# Access Compliance Report

## Public Rights-of-Way

Intersection ID: 25420	Main Street: MCPHERSON_DR	Cross Street: WYMAN_LN	Location: NW
ADA ID: 23FAA7082D2A	Ramp Type: Directional1	Initial Pass/Fail: Fail	Overall Compliance: No
		Severity Score: 8.75

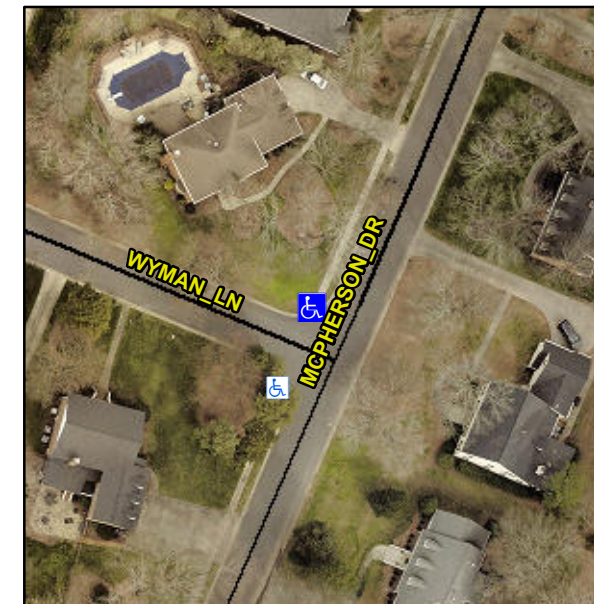
**R304.5.1**

**Remove & Replace Entire Ramp.**
